REVISED DATA GAP WORK PLAN

580 Market Place Shopping Center
3735-4065 East Castro Valley Boulevard
Castro Valley, California
ACEHD Case No. RO0003097

**Subject: Revised Data Gap Work Plan
Alameda County LOP No. RO 3047
Cardno ATC Project No. 75.75354.0002**

On behalf of Weingarten Realty Investors (Weingarten), Cardno ATC (Cardno) is submitting this Revised Data Gap Work Plan to address comments received from the Alameda County Environmental Health Services (ACEH) on Cardno's previously submitted *Data Gap Work Plan*, dated November 30, 2012. On August 28, 2013, comments and recommendations on the original work plan were relayed to Weingarten and Cardno in a conference call with the ACEH and summarized in an email from the ACEH on the same date.

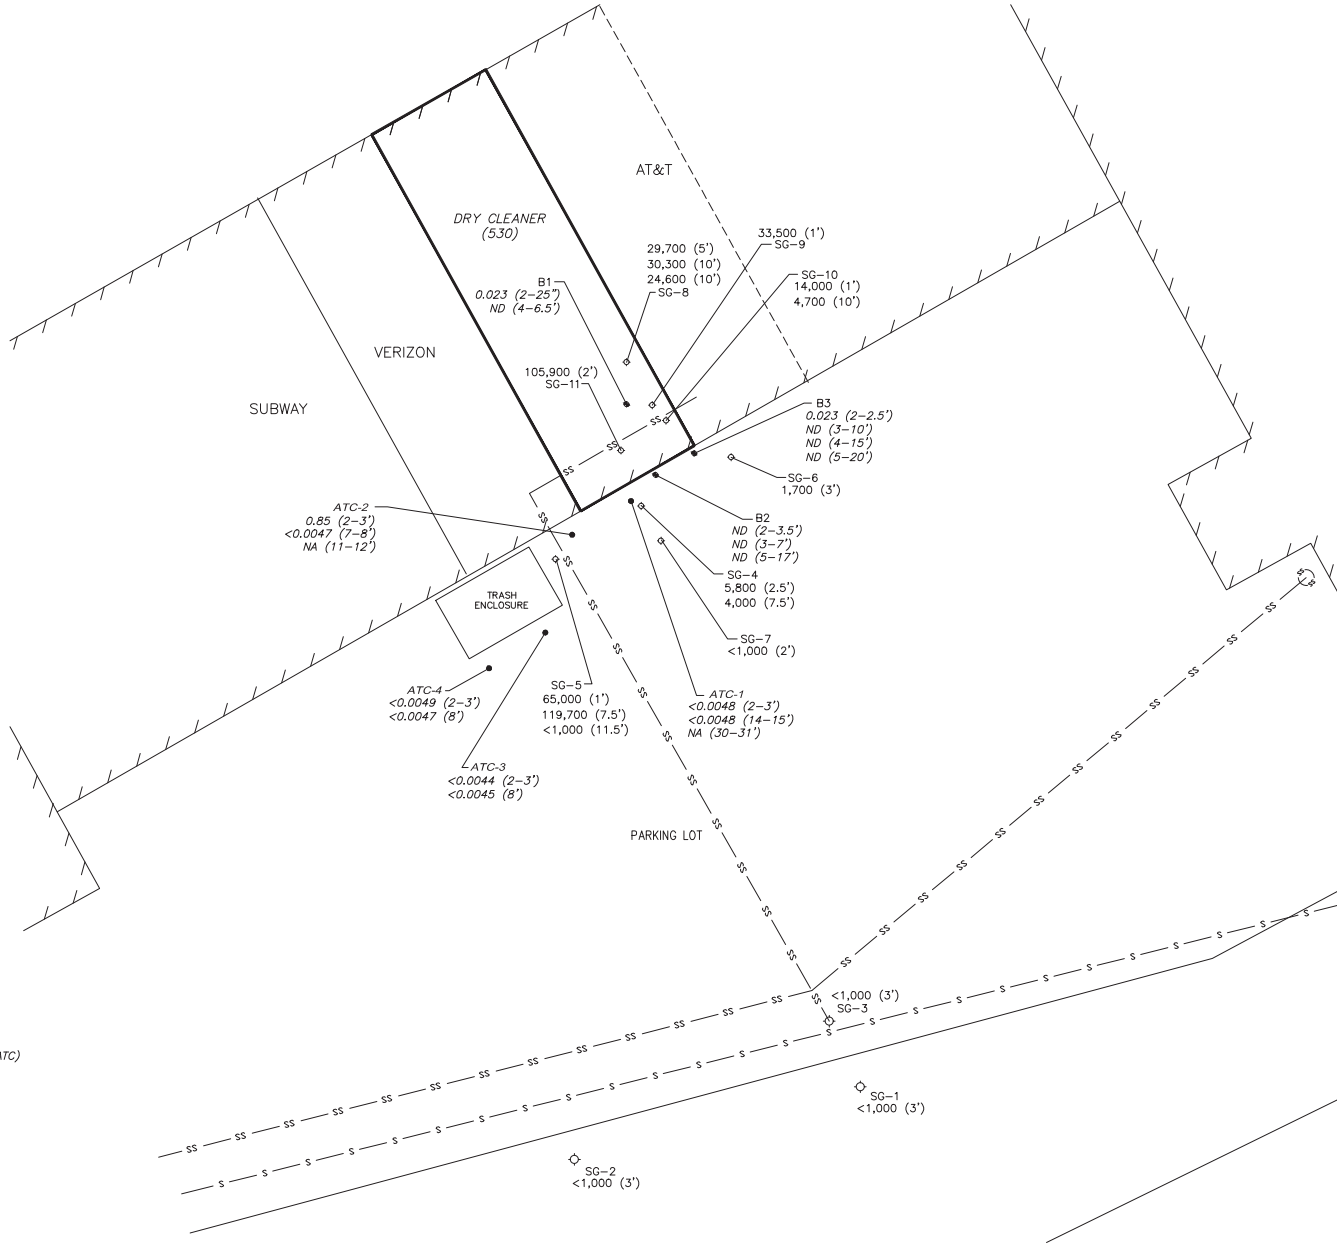
5. *Include information on known utilities beneath the slab and foundation specifications (slab thickness, plumbing penetrations, condition of cracks, etc.).*

9. *Synthesize all known site data, including, but not limited to, locations of former dry cleaning equipment, utilities, soil borings, and soil gas probes on figures to be included with the Addendum. Present tables summarizing all past and present soil and soil gas*

Cardno Comment: Cardno has incorporated known utility locations into figures included in this report. Cardno has no new information regarding slab thickness or potential presence of cracks in the building slab/foundation. Cardno will gather this information during implementation of the proposed scope of work.

Cardno Comment: Cardno has incorporated pertinent historical data into the revised work plan.

PROJECT NUMBER: 75-7594-002
 APPROVED BY: GS
 DATE: 11/8/13
 DRAWN BY: BK
 FIGURE 3
 ATC
 701 University Avenue, Ste. #200
 Sacramento, California 95825
 Ph: (916) 923-1097 *** Fax: (916) 923-6251

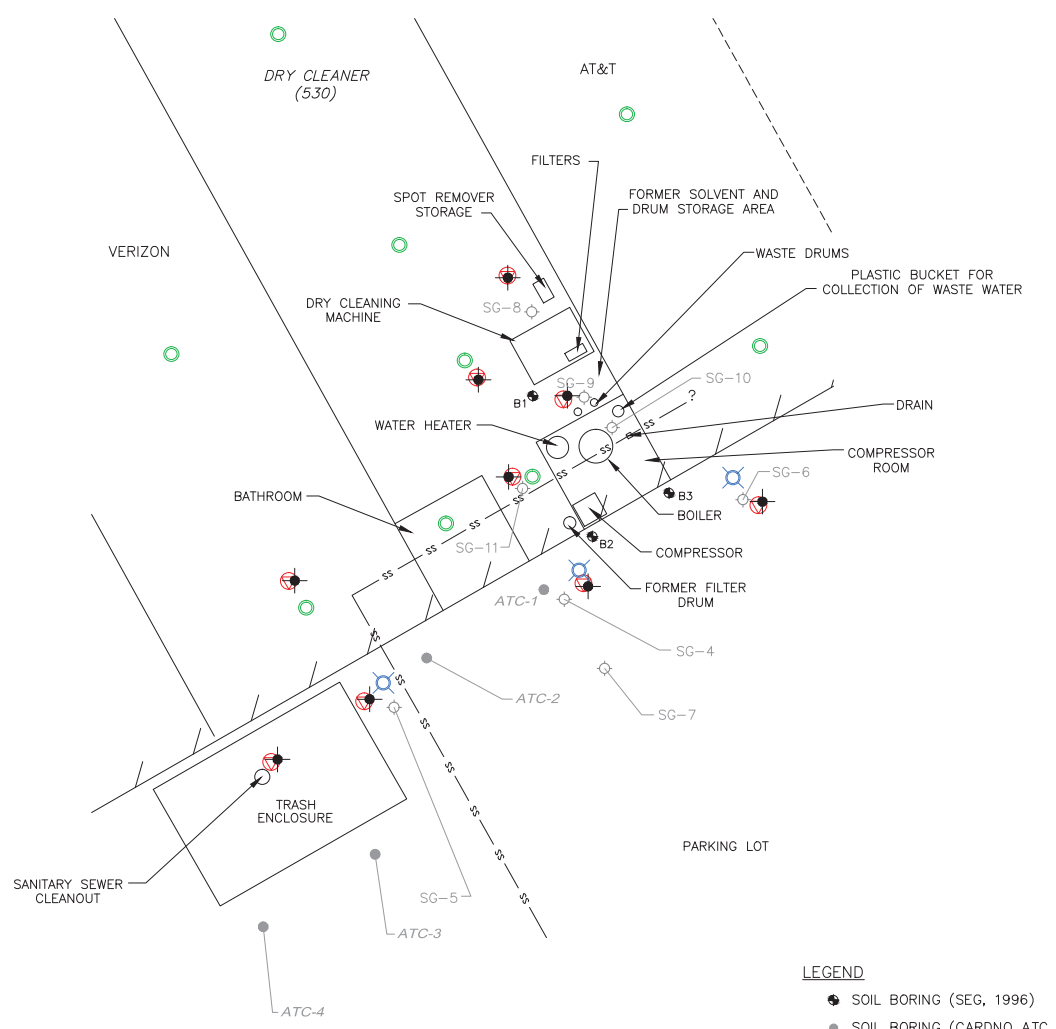
1. *Prepare an indoor air sampling scope for the current dry cleaning business including Indoor air sampling may be required in adjacent spaces if results of the soil vapor investigation indicate a potential for vapor intrusion into those tenant spaces.*

2. *Vertical soil gas profiling in the drycleaner should be performed to help identify source locations; include a contingency plan with the rationale for step-out locations if soil vapor results indicate hot spots.*

3. *Include installation of permanent soil vapor probes inside the dry cleaning space to facilitate collection of seasonal data.*

Cardno Comment: Cardno has included a scope of work for the indoor air sampling of the dry cleaning facility and adjacent units in the revised work plan scope presented below.

Cardno Comment: In a telephone conversation on September 5, 2013, the ACEH agreed with Cardno's recommendation to use a membrane interface probe (MIP) in place of vertical soil vapor profiling to further define the vertical and horizontal extent of impacts. Therefore, the revised work plan includes a scope for a MIP assessment, but not for vertical soil gas profiling.

Cardno Comment: Cardno has included a scope for the installation of permanent vapor probes in the revised work plan.
